# NRC INSPECTION MANUAL

## INSPECTION MANUAL CHAPTER 0609 APPENDIX D

#### PUBLIC RADIATION SAFETY

#### DRAFT REVISION FOR EXTERNAL STAKEHOLDERS

# PUBLIC RADIATION SAFETY

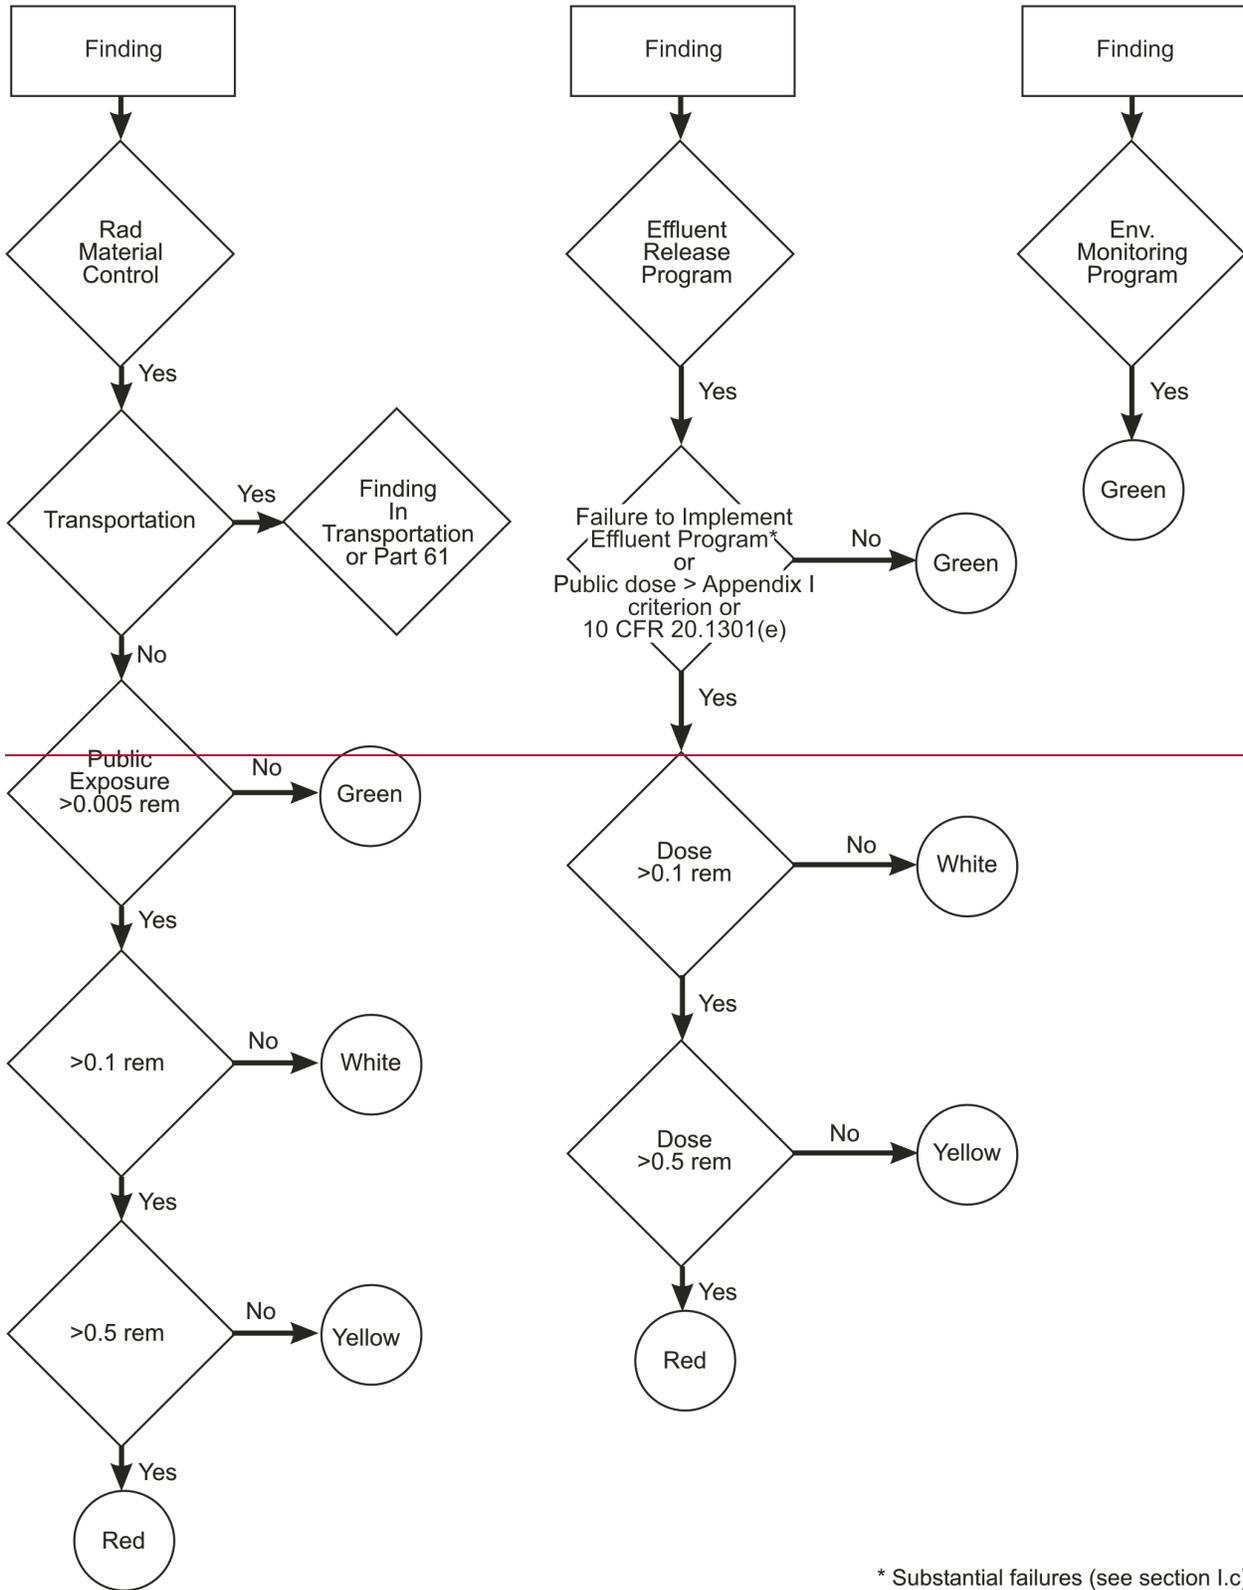
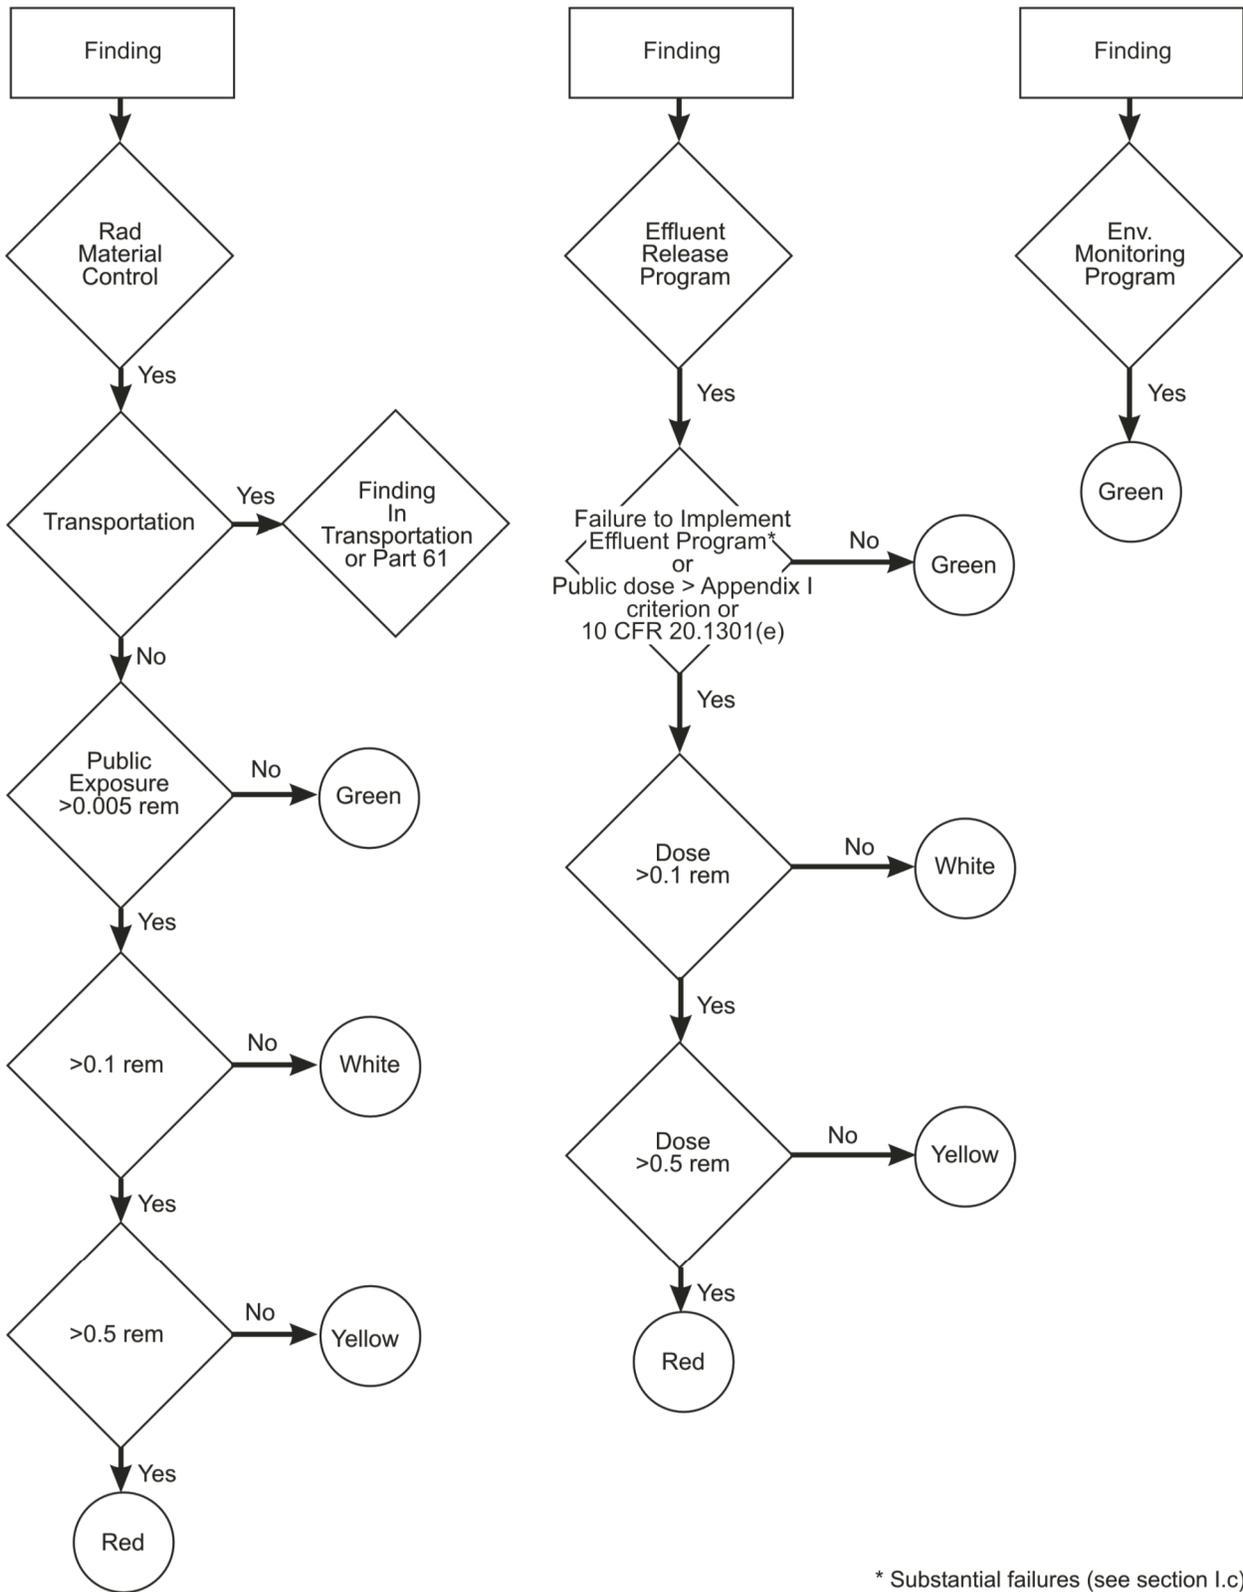
The significance determination process (SDP) in this Appendix is designed to provide a means by which NRC inspectors and management can assess the significance of inspection findings related to public health and safety from exposure to radiation from licensed or unlicensed radioactive materials during routine operations of civilian nuclear power reactors. This process is used in conjunction with Inspection Procedure ~~71122, a Public-71124, "Radiation Safety, @-~~ Public and Occupational," to determine the risk significance of ~~a finding-inspection findings.~~ A single issue may be evaluated using all applicable branches of the SDP ~~andwith~~ the significance determined by the ~~most restrictive~~ outcome, that provides the highest significance. IP ~~71122 has71124 implements~~ three ~~inspection areas~~ Inspectable Areas<sup>1</sup> within the Public Radiation Safety Cornerstone:

~~This~~The Radioactive Effluent Release branch of the logic diagram focuses on the ~~licensee=licensee's~~ routine (i.e., non-accident) radioactive effluent release program. This branch addresses ~~performance deficiencies~~ findings associated with radioactive effluents, leaks and spills and direct radiation from the facility. It assesses the licensee's ability to monitor and maintain radioactive effluents to levels that are as low as is reasonably achievable (ALARA (i.e.,) as demonstrated by radioactive effluents being within the design dose objectives contained in Appendix I to 10 CFR Part 50 and the U.S. Environmental Protection Agency's (EPA) standards pursuant to 10 CFR 20.1301(e). Being able to assess dose from radioactive effluents and maintain radiation doses to a member of the public within Appendix I design

Is there a finding in the ~~licensee=~~licensee's radiological effluent monitoring program that is contrary to NRC regulations or the ~~licensee=s Technical Specifications (TS);~~licensee's TS, Offsite Dose Calculation Manual (ODCM), or procedures? Is there an indication of a spill or release of radioactive material on the licensee's site or to the offsite environs? If yes, was the licensee able to assess the dose to members of the public from the release of radioactive effluent and what is the dose impact (as calculated by the licensee) for the event? If the dose impact to a member of the public from the radiological release, spill or leak is less than the dose values in Appendix I to 10 CFR Part 50 and/or 10 CFR 20.1301(e), then there is minimal ~~A~~risk

and the SDP classifies ~~it~~this finding as GREEN. -The licensee is responsible to resolve the finding-underlying performance deficiency that resulted in this finding. The NRC will periodically inspect the effectiveness of the ~~licensee=~~licensee's corrective action program.

### Packaging and Radiation Limits

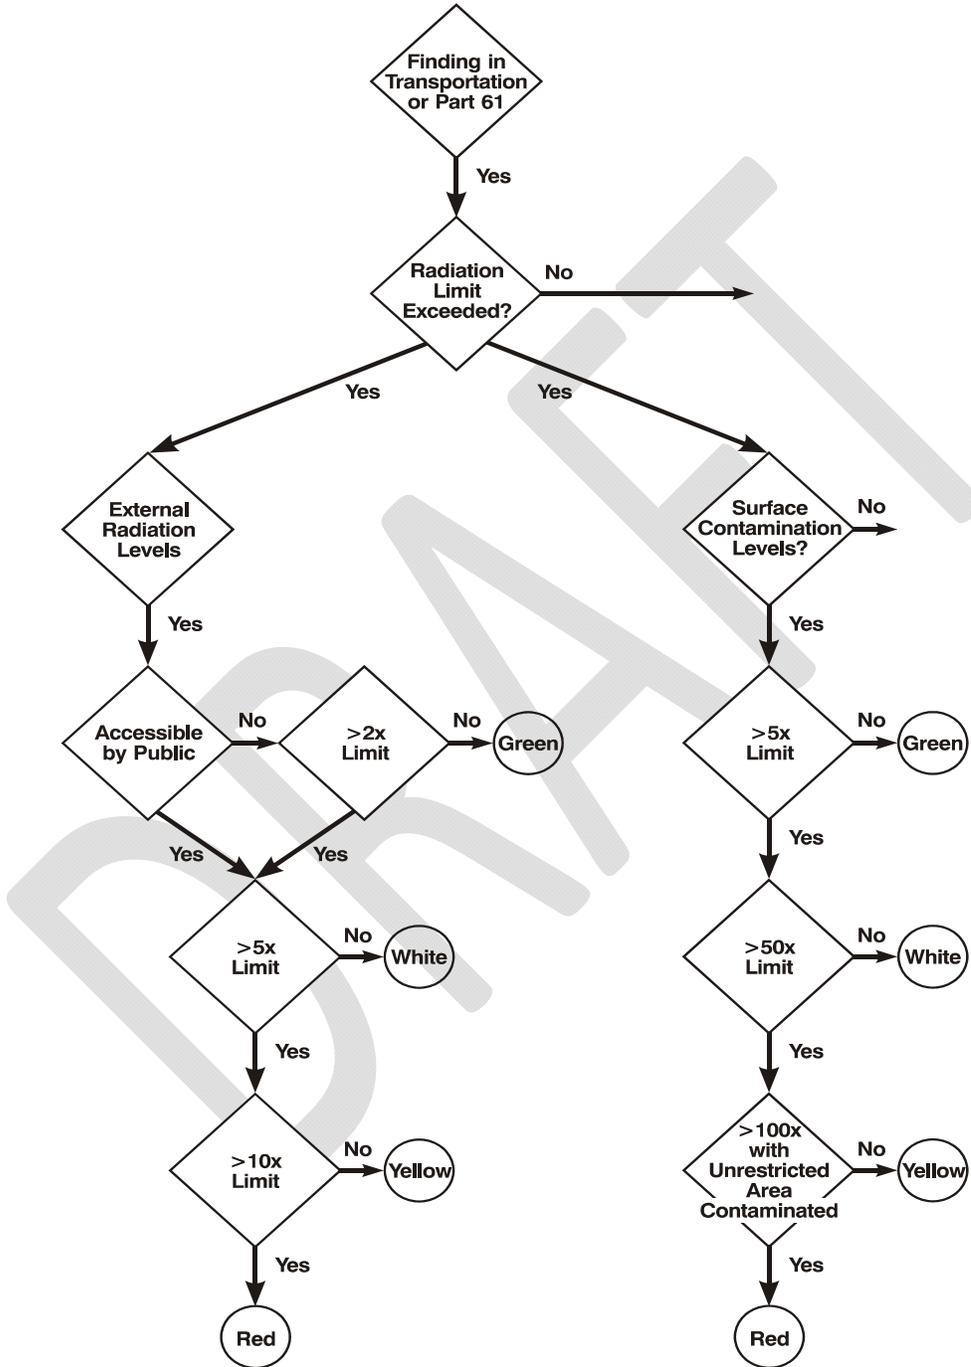
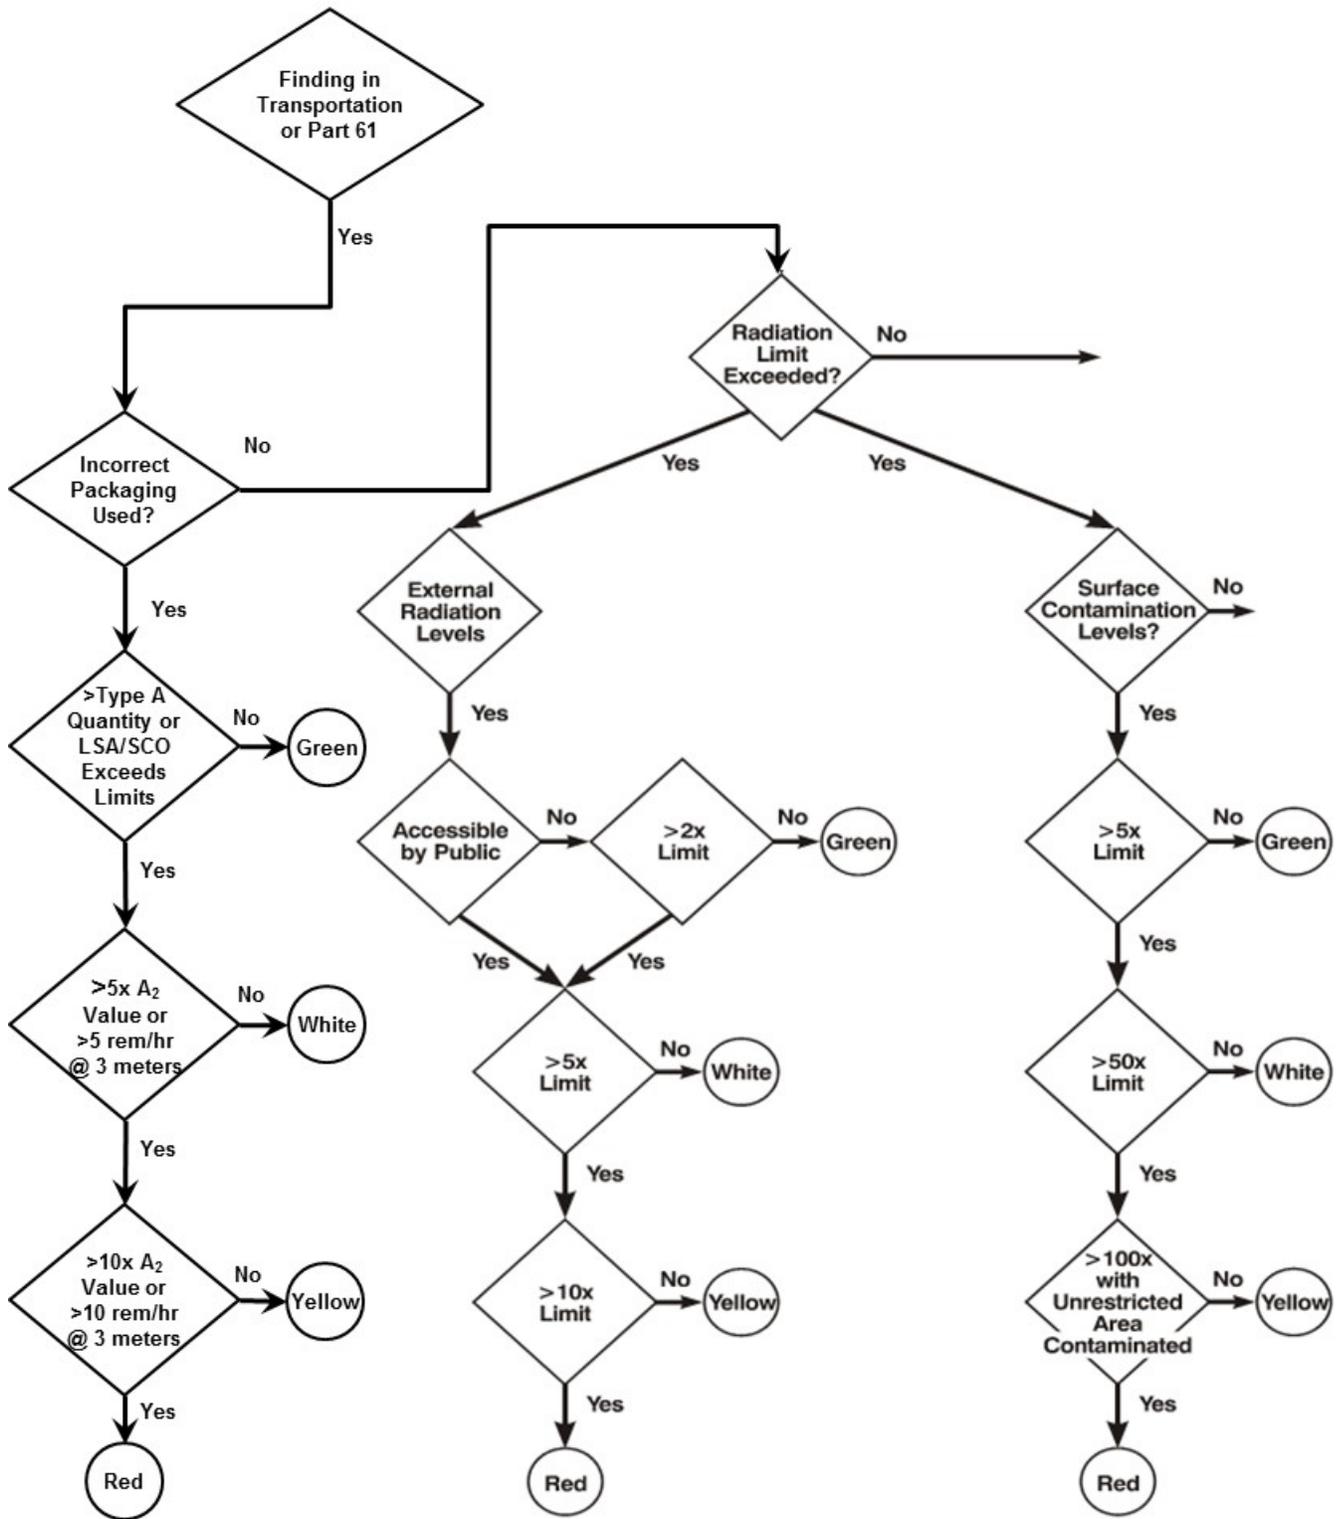
When incorrect packaging is used and the shipped material exceeds a Type A quantity, or is composed of LSA or SCO that exceeds the applicable conditions of transport of 49 -CFR -173.427, then the finding would be WHITE; otherwise the finding would be GREEN. If the shipped material exceeds multiples (i.e. 5x and 10x) of the Type A limit or, in the case of LSA or SCO, the approximate external exposure at 3 meters corresponding to those multiples, as applicable, then the significance of the finding increases to YELLOW and RED, respectively. This branch of the SDP categorizes the significance of a licensee's failure to properly package and ship radioactive material (regardless of whether the shipment occurred without incident) and to provide a suitable input to the assessment process that would result in the appropriate level of supplemental inspection in response to that failure.

The external radiation level branch provides for a graded approach for assessing/determining the level-of-significance of findings. Exceeding the limit yields a GREEN finding and then with increasing multiples/multiples of the limits/limit provides for GREEN, WHITE, YELLOW and RED findings. To assess the significance of a finding, consideration is/should be given to risk-informing findings based on the accessibility of the package, to members of the public. An accessible area is defined in the>this SDP as an area that can reasonably be occupied by a major portion of an individual-individual's whole body. The definition of whole body is/can be

The removable surface contamination level branch provides for a graded approach for assessing the level of significance of findings. Exceeding the limit yields a GREEN finding and then ~~with increasing multiplies multiples~~ of the ~~limits provide~~ limit provides for GREEN, WHITE, YELLOW and RED findings. Note that to have a RED finding, the surface contamination levels must not only exceed 100 times the limit, but the unrestricted area must have been contaminated as well.
